**Flood Control Project Maintenance
Levee Inspections**

Maintenance Issue Types Only, Levee Inspection Report By Mile - Spring 2022

Brannan Andrus Levee Maintenance District

Waterway	Bank	Unit Miles	Inspection Start/End	Inspector
Unit No. 01 Georgiana Slough	Right	6.01	03/11/2022 03/11/2022	David Julian

Photo 1 of 2 : SP_2022_NA0002_63_71_20220329_00028.jpg

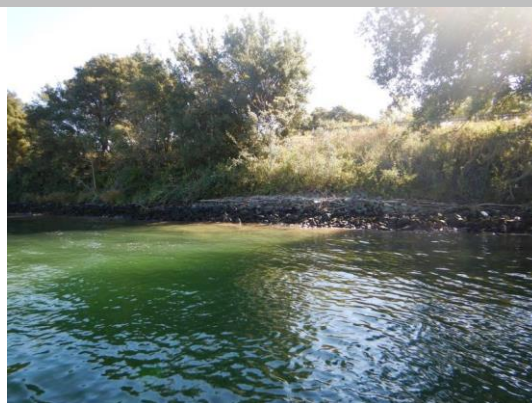
2018 Site ID: SAC 18.1 L
 Status: Critical
 2018 Field Notes: Increased vegetation made it difficult to see changes.
 Site History: 2009 - Short reach of vertical bank at the toe. 2010 - Large tree is getting ready to fall in. 2015 - Freshly exposed tree roots. 2017 - Upgraded to CRITICAL. Vertical slope face behind a tree that is likely to pop-out soon.

Photo 1 of 1 : SP_2022_NA0002_63_92_20220329_00041.jpg

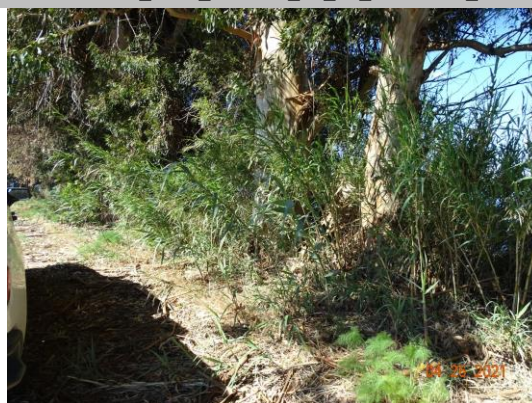
LM Start	8.17	Rating **	M	Issue No.	92	
LM End	8.17	Issue Type +	Ma	Location *	WS	
Category	Earthen Levee			GPS Latitude/Longitude		
				Start		End
Item	Vegetation			38.152255 °		38.152255 °
				-121.681607 °		-121.681607 °
DWR ID	DWR_NA0002_02_f_2019_92					
Comment Code						
V2 : Remove the wild growth and woody vegetation other than native grasses from the levee slopes.						
Inspector Comment						
Remove arundo on the waterside slope.

View of arundo on the waterside slope (Spring 2021).
